Narrabri Gas Project Response to Submissions

This response to submissions on the Environmental Impact Statement is the next step in the comprehensive NSW government assessment process and confirms the Narrabri Gas Project can be developed safely and sustainably.

To prepare this Response to Submissions (RTS), the submissions were reviewed and issues raised requiring a response were identified and considered.

Figure 5-2

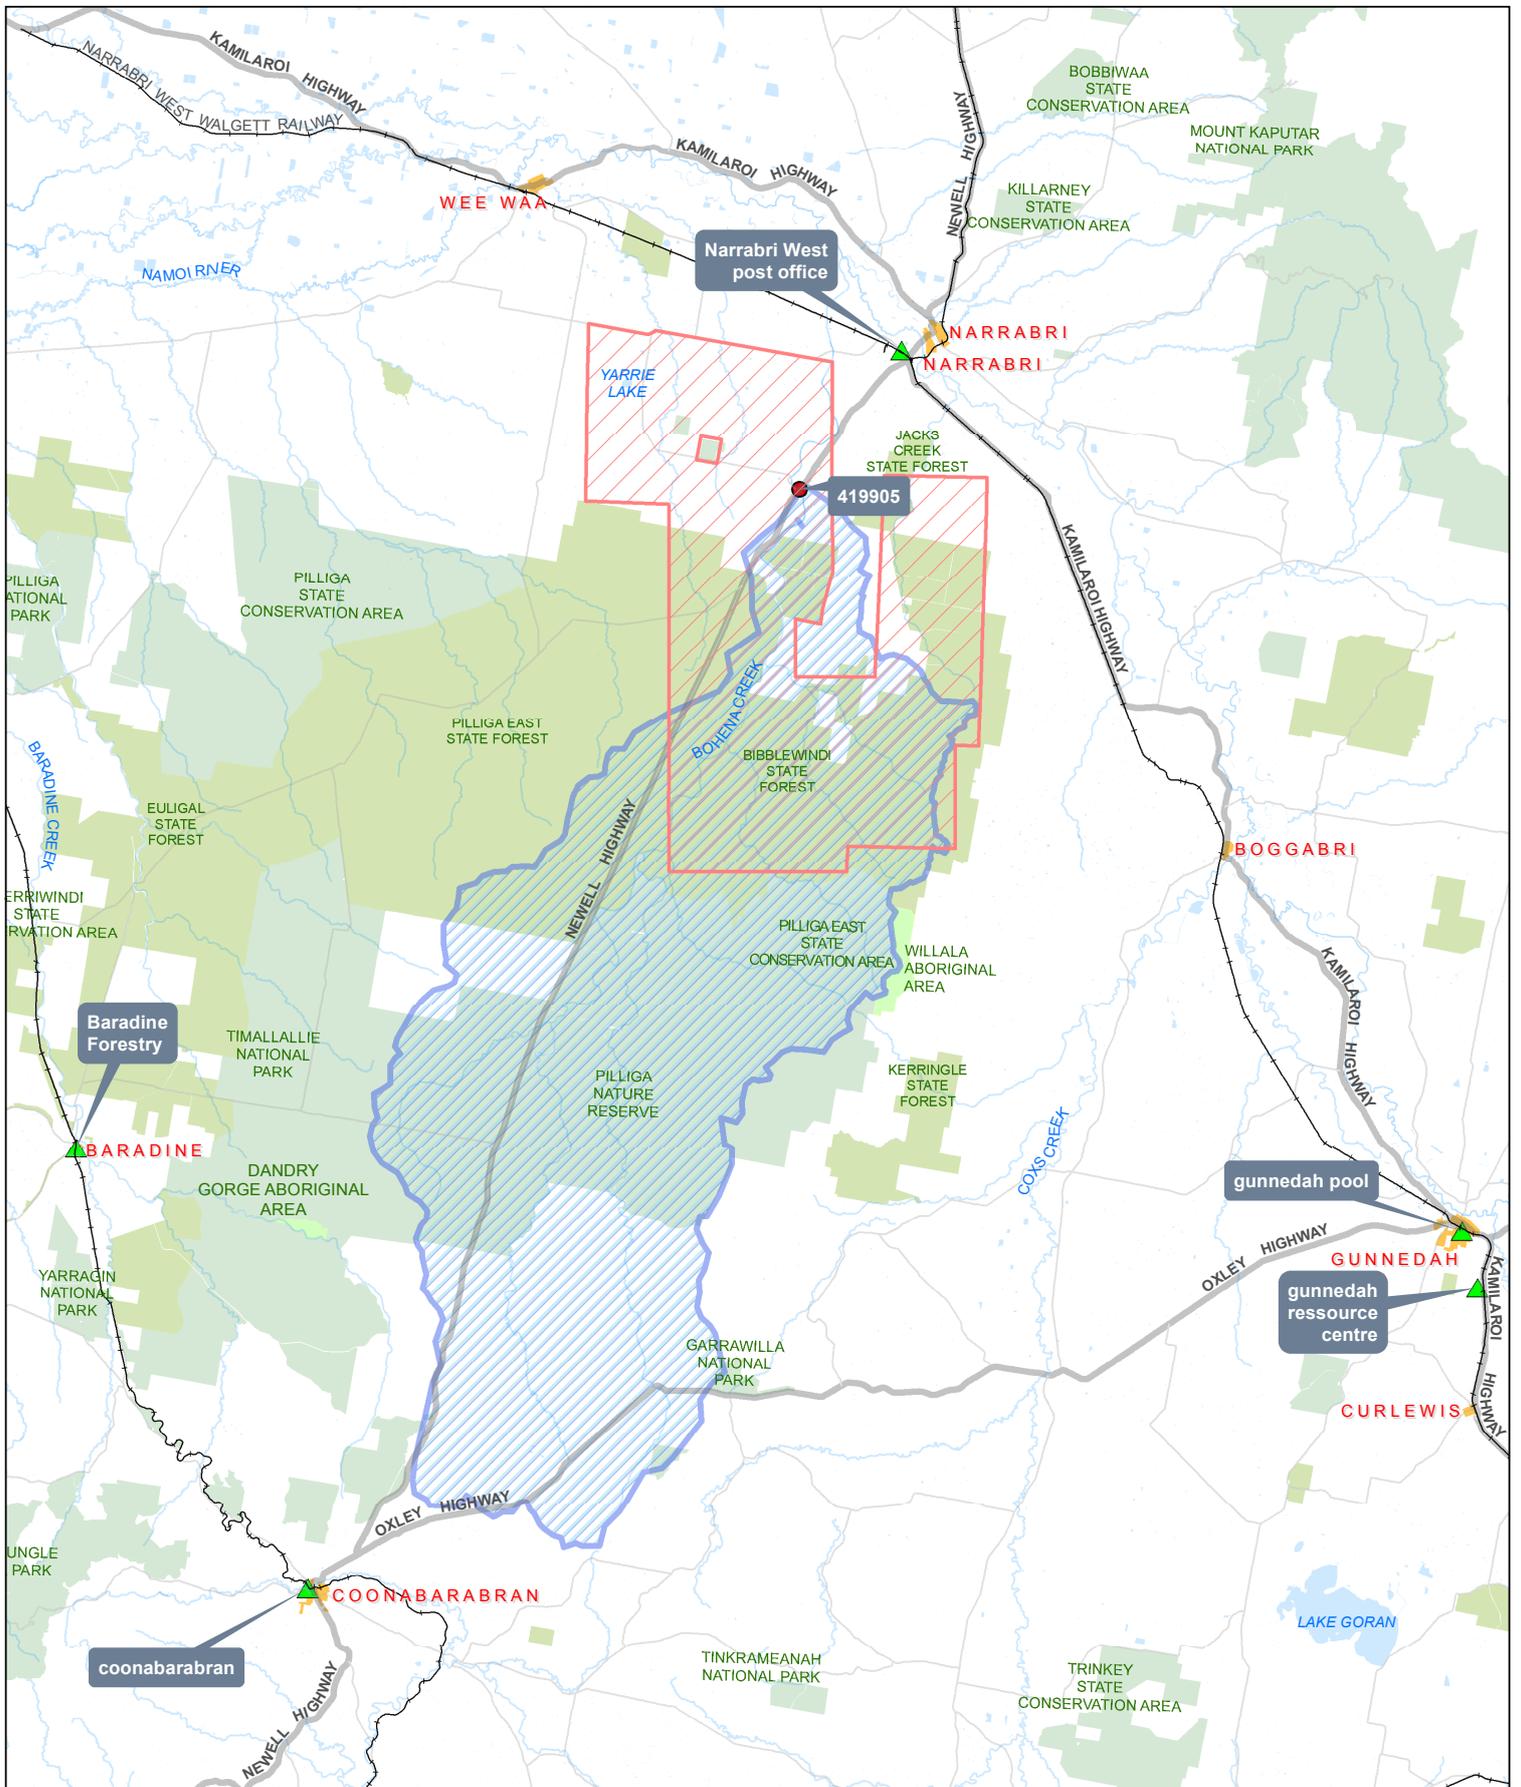
The submission raised some minor technical clarifications of the flood study in Appendix A of Appendix H of the EIS. These minor technical clarifications were as follows:

- Figure 2-1 omitted missing gauges, now included in Figure 5-2 in this RTS.
- Section 3.6: The rate of the rising limb of the adopted rainfall pattern for the 1998 event, at around 24 hours, is very similar to that of Narrabri West and Gunnedah reflecting the relatively rapid response at these gauges.

Figure 6-24 EIS groundwater modelling – simulated steady-state water balance

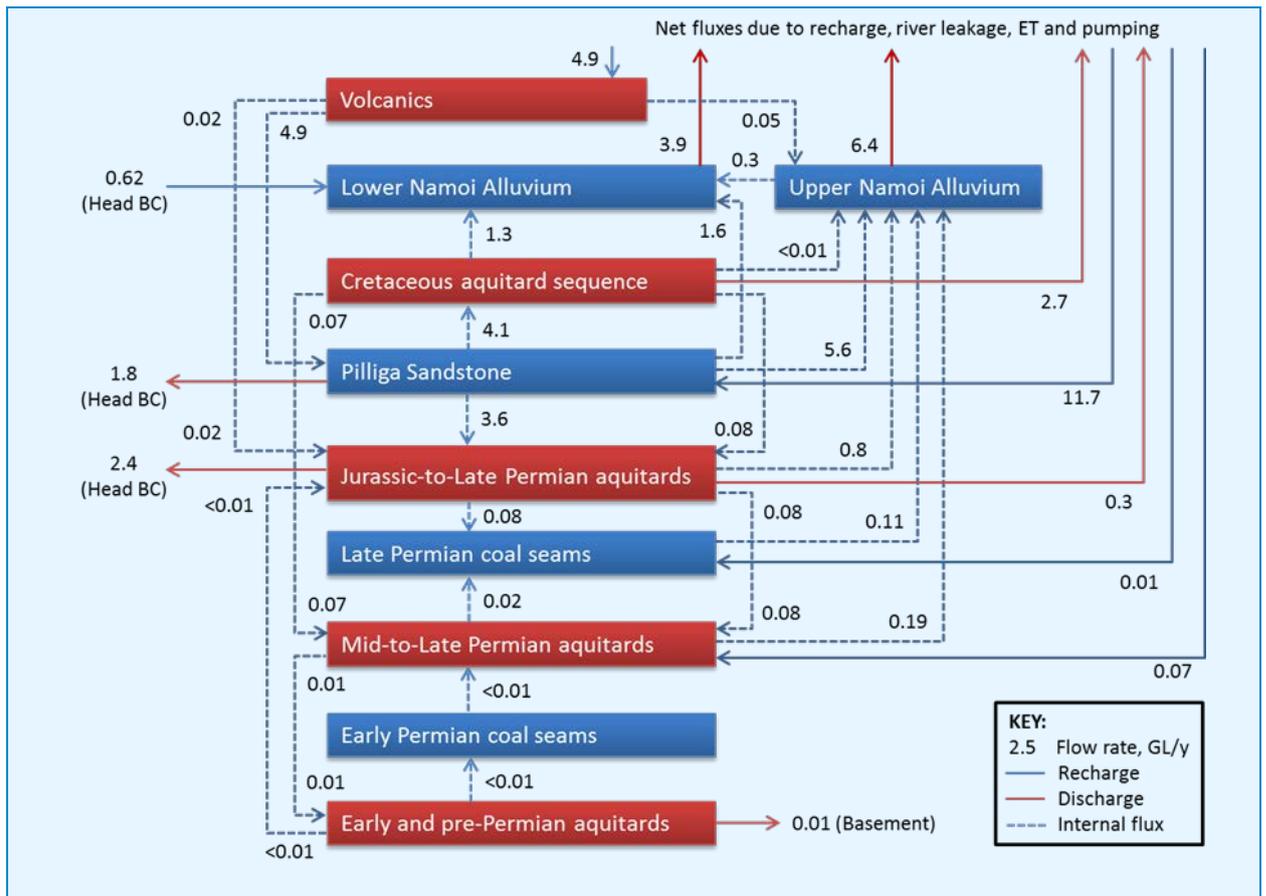
Figure 6-23 was not presented in the EIS, whilst Figure 6-24 differs from the EIS version (Appendix F; Figure 6-18) with respect to the groundwater flux of 1.6 GL/y (4.5 ML/d), now shown by the additional arrow extending from the Pilliga Sandstone to the Lower Namoi Alluvium. The original figure contains an accounting error, whereby this flux to the Lower Namoi Alluvium was included in the flux component from the Pilliga Sandstone to the Upper Namoi Alluvium.

The groundwater modelling for the EIS incorporates enhanced vertical connection between the Great Artesian Basin and Lower Namoi Alluvium in the area between Narrabri and Wee Waa where the Pilliga Sandstone directly underlies the Lower Namoi Alluvium (Figure 6-22). A map of steady-state artesian leakage between the Great Artesian Basin and Lower Namoi Alluvium from the modelling is shown in Figure 6-23 and the simulated steady-state water balance (corrected from that issued in the EIS) is reproduced in Figure 6-24.
